May 30, 2001

Subject: McGuire Nuclear Station, Units 1 and 2  
Docket Nos. 50-369 and 50-370  
Supplement to Proposed Revision to Technical  
Specifications (TS) Submittal dated February 14, 2001  
TAC Numbers MB1261 and MB1262

WCAP-15192 REVISION 1

**McGuire Unit 1  
Heatup and Cooldown Limit Curves  
For Normal Operation**

Figure 3.4.3-1

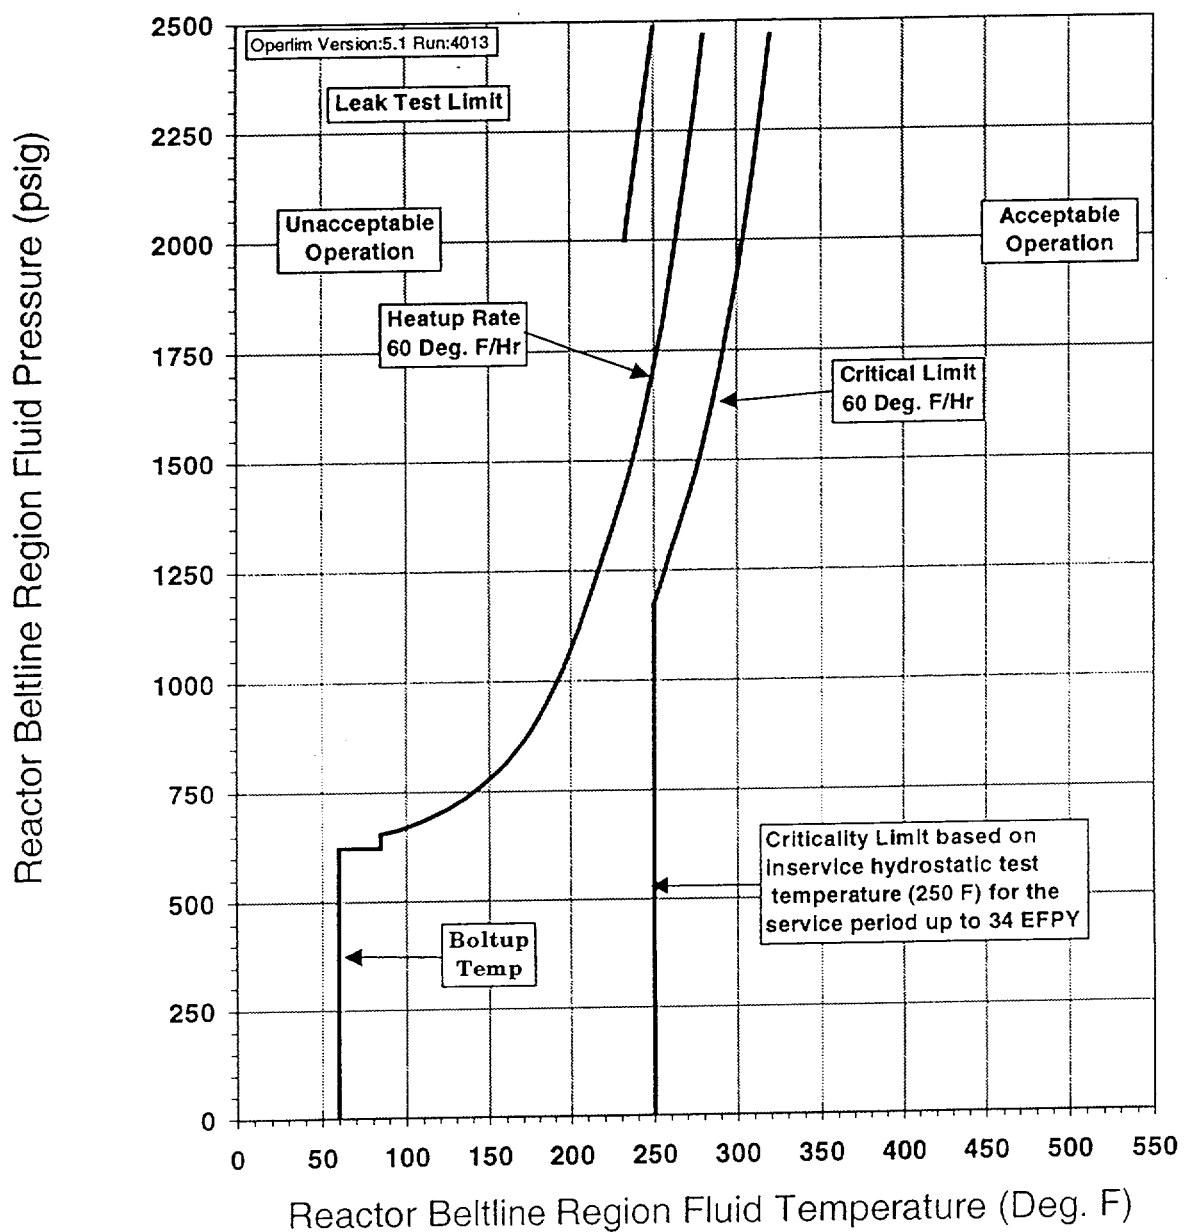
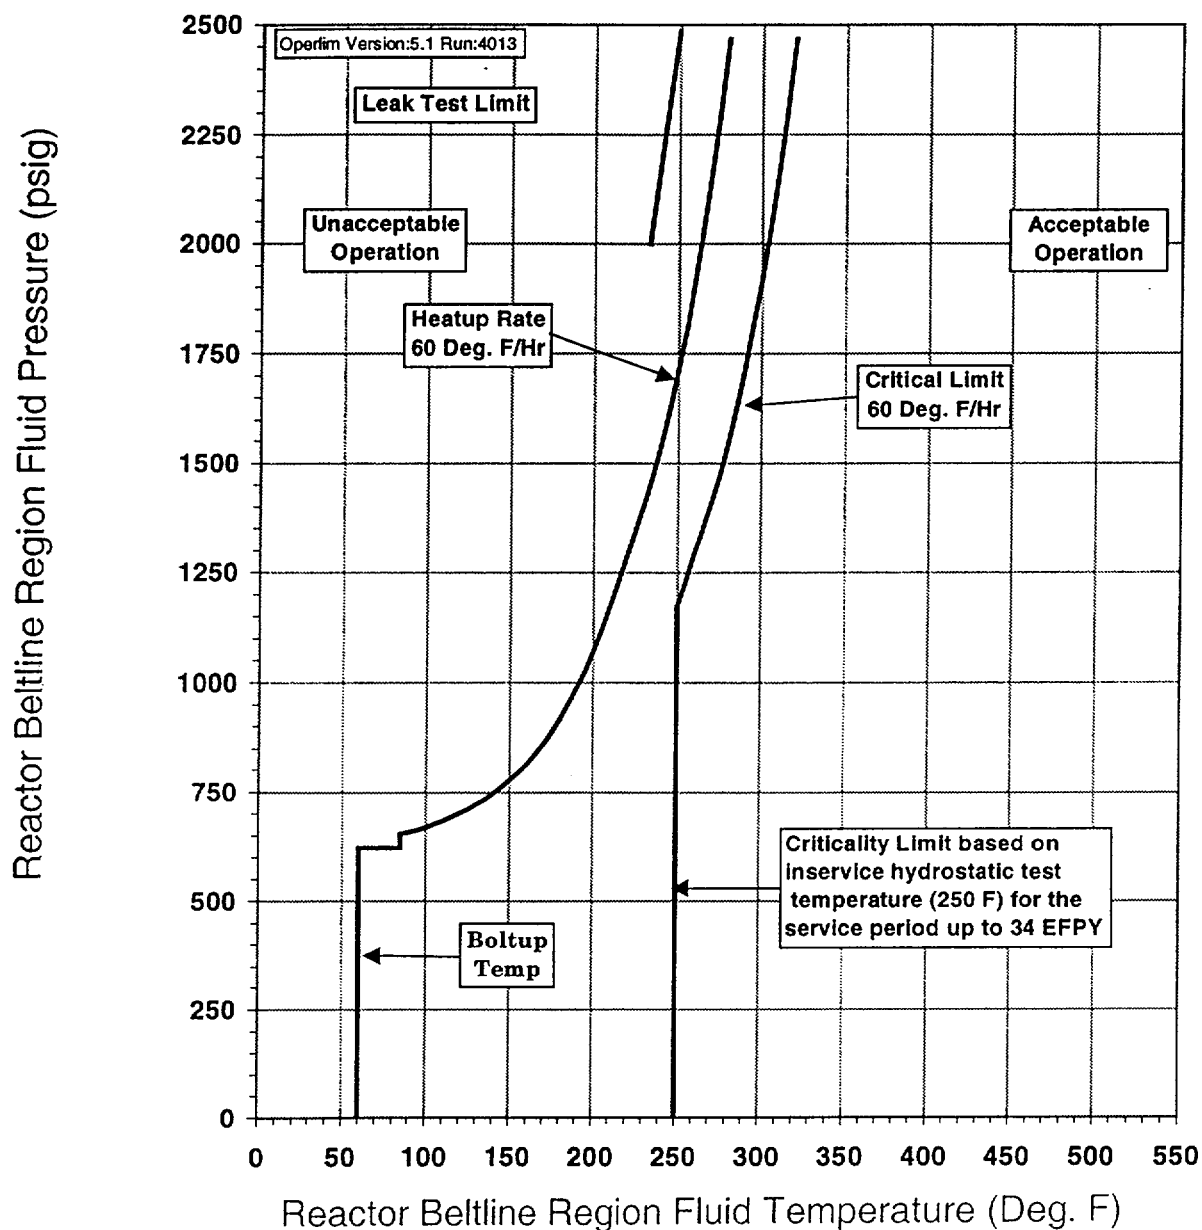
1/ In Attachment 1 of the submittal, replace Pages 3.3.2-11, 3.3.2-12, B 3.3.2-16, B 3.3.2-17, B 3.3.2-18, Figures 3.4.3-1, 3.4.3-2, 3.4.3-3 and 3.4.3-4 with the corresponding pages as included in Attachment 1 of this supplement.

2/ In Attachment 2 of the submittal, replace Figures 3.4.3-1, 3.4.3-2, 3.4.3-3 and 3.4.3-4 with the corresponding figures as included in Attachment 2 of this supplement.

Revision 1 of the WCAP reports corrects the error detected in the computer program used to generate the heatup and cooldown curves. This correction resulted in changes to the heatup curves (Figures 3.4.3-1 through 3.4.3-4) in the submittal. The cooldown curves were not affected. The revised heatup curves are slightly more restrictive but do not affect Duke Energy's low temperature overpressure protection analysis. The revised WCAPs only affect the heatup curves. Pages 3.3.2-11, 3.3.2-12, B 3.3.2-16, B 3.3.2-17, and B 3.3.2-18 in Attachment 1 of the submittal are replaced with corresponding pages to reflect the latest approved version of the McGuire Technical Specifications and corresponding Bases. The remaining attachments of the original submittal including the technical justification, no significant hazards consideration evaluation and environmental impact assessment remain valid for NRC review and approval.

FIGURE 5-1 McGuire Unit 1 Reactor Coolant System Heatup Limitations (Heatup Rate of 60°F/hr) Applicable to 34 EFPY (Without Margins of for Instrumentation Errors)

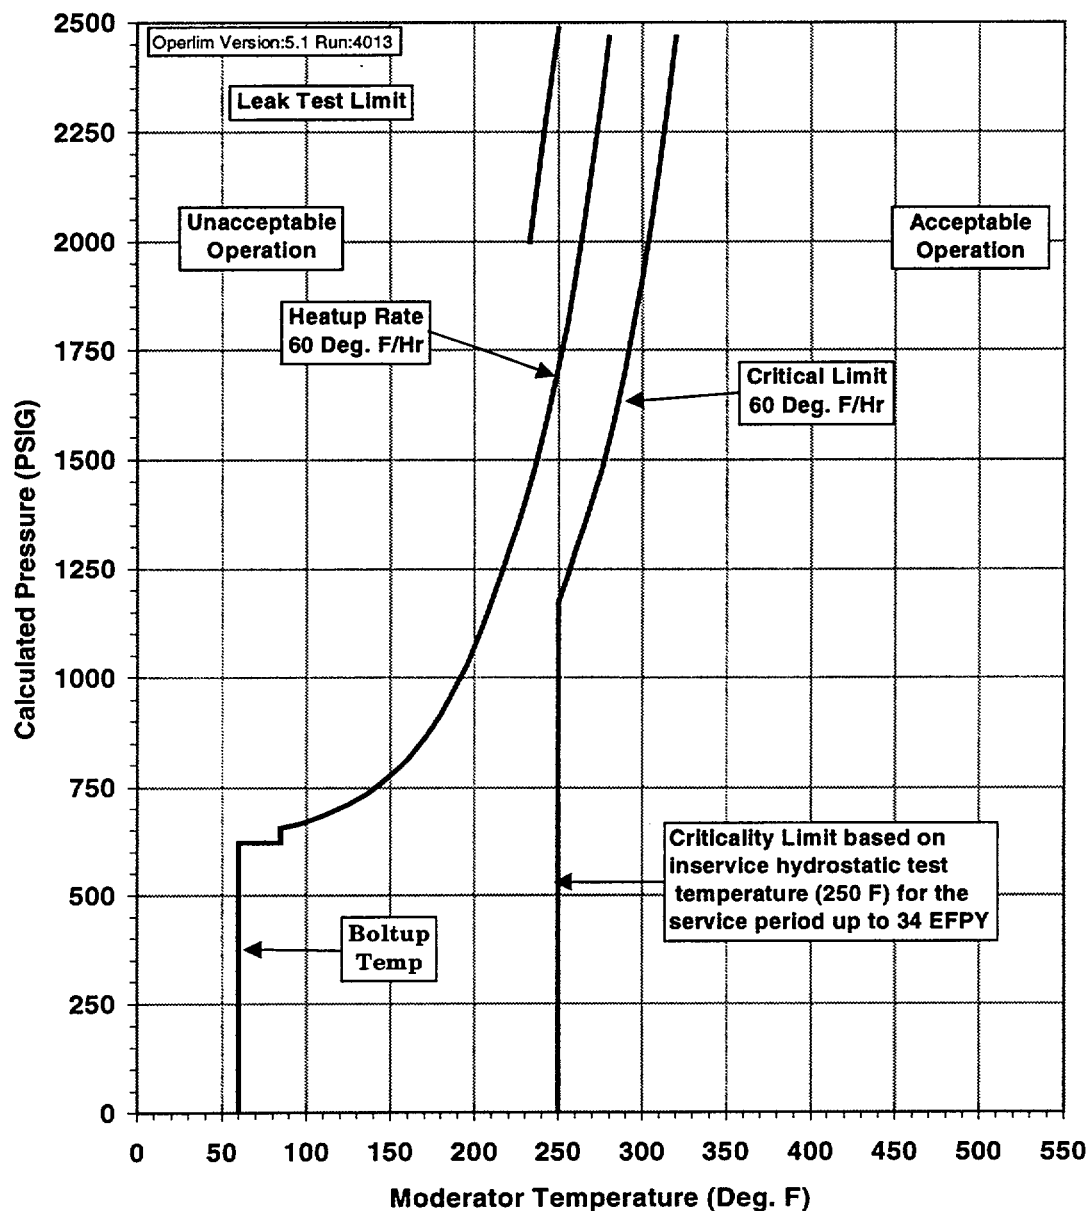
An error was detected in the "OPERLIM" Computer Program that Westinghouse uses to generate pressure-temperature (PT) limit curves. This error potentially effects the heatup curves when the 1996 Appendix G Methodology is used in generating the PT curves. It has been determined that WCAP-15192 Rev. 0 was impacted by this error. Thus, this revision provides corrected curves from WCAP-15192 Rev. 0.

Note that only the heatup curves and associated data point tables have changed. The cooldown curves and data points remain valid and were not changed.
